REFERENCE:	Nova Bus Manuals
SECTION:	10: Transmission and Control
RS N°:	MQR 7621-2486
EFFECTIVE IN PROD.:	N/A

SUBJECT:	Transmission Coolant Pipes
JUSTIFICATION:	P-clamps holding the transmission coolant pipes can break and cause coolant leaks.

Figure 2 - The two P-clamps Securing the two Transmission Coolant Pipes

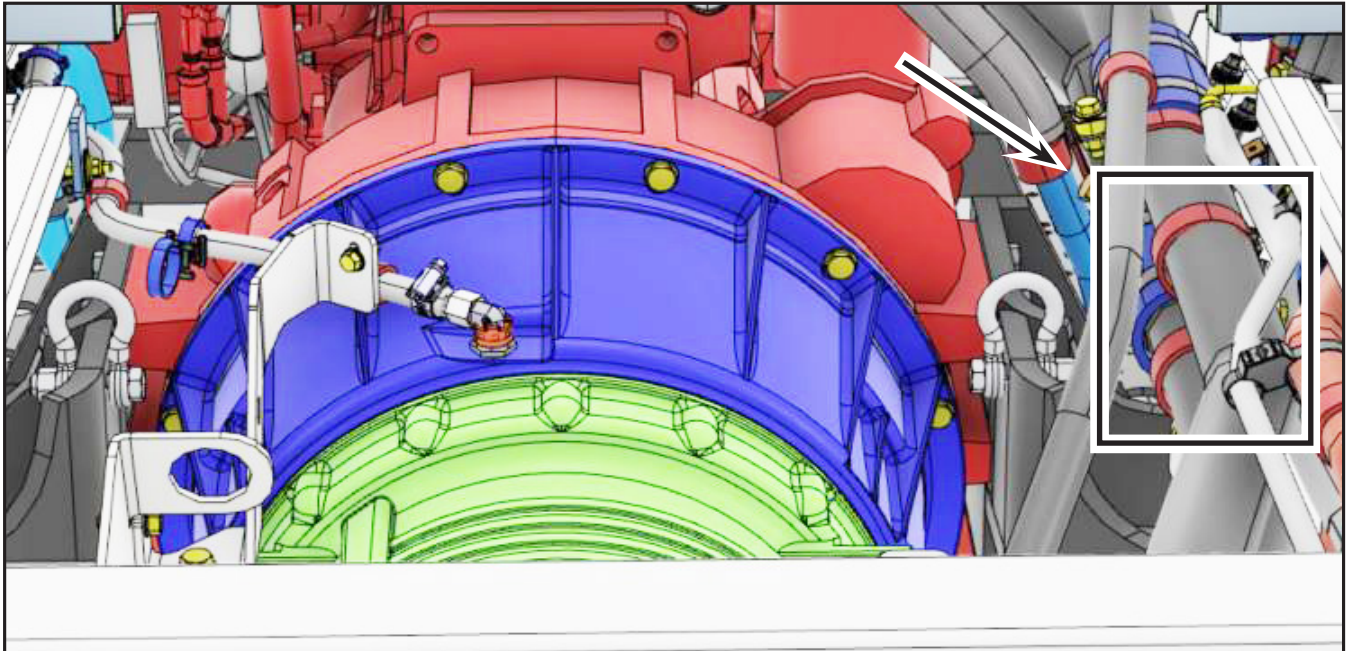
LEVEL	DESCRIPTION	DIRECT CHARGES		TIME
		LABOUR	MATERIAL	
1	Replace two installed P-clamps with two thicker ones.	Nova Bus	Nova Bus	1 h
2	–	–	–	–

- 1.5. Locate the two P-Clamps mounted on the engine cradle bracket that secure the two coolant pipes (Figure 2).
- 1.6. Remove the two P-clamps, keep the spacer, the screws and the nuts. Discard the P-clamps (Figure 3).
- 1.7. Prior to their installation, it is recommended to pre-bend/preform the 2 new P-clamps N31320-09 to facilitate their installation.
- 1.8. Install the two new P-clamps with the removed spacer, screws and nuts. Torque to the torque value of 17 ± 2 lb-ft (23 ± 2 N•m).
- 1.9. Close the transmission access trap.
